Technical Service Bulletin (TSB)

Global Telematics Box Module (TBM)

Firmware Over The Air (FOTA) Update

REFERENCE:	TSB: 08-198-26 GROUP: 08 - Electrical	Date:	May 2, 2026	REVISION:	–
VEHICLES AFFECTED:	2026 (WL) Jeep Grand Cherokee / Grand Cherokee L This bulletin applies to vehicles built on or before January 28, 2026 (MDH 0128XX) equipped with Global Telematics Box Module (Sales Code RDG).			MARKET APPLICABILITY: ☒ NA☐ MEA ☐ SA☐ IAP ☐ EE☐ CH NOTE: This bulletin applies to the North America market.	
CUSTOMER SYMPTOM:	Customers must experience a Malfunction Indicator Lamp (MIL) illumination and the vehicle must exhibit/set one or more of the following Diagnostic Trouble Codes (DTCs): - B22A9-96 ECU Internal Performance-Component Internal Failure. - B1560-11 Cellular Antenna 1 - Short To Ground. - B1560-13 Cellular Antenna 1 - Circuit Open. - B1561-11 Cellular Antenna 2 - Short To Ground. - B1561-13 Cellular Antenna 2 - Circuit Open. - B1562-14 GPS Antenna Short To Ground Or Open. Customers may also experience the following: "Uconnect Box Required Service" message in Radio Display.

**Fig. 1**

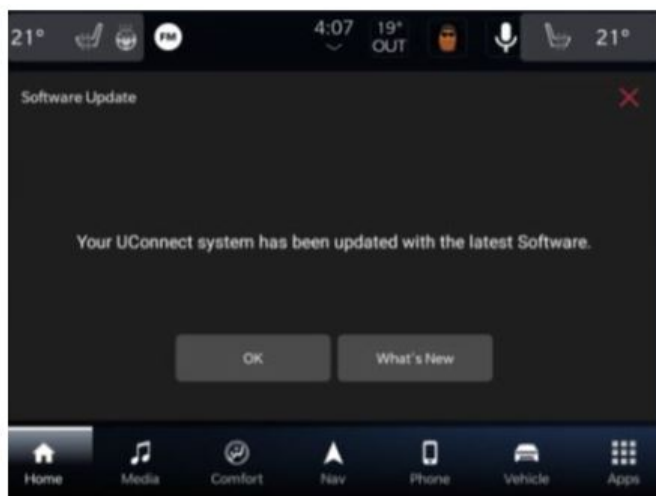
1. The vehicle needs to be in 'Park'. The ignition needs to be in the off position.
2. If the customer selects "Update Now" [Fig. 2](#) they can shut off the vehicle and leave. The update will be completed automatically.

NOTE: This step may take several minutes to complete.
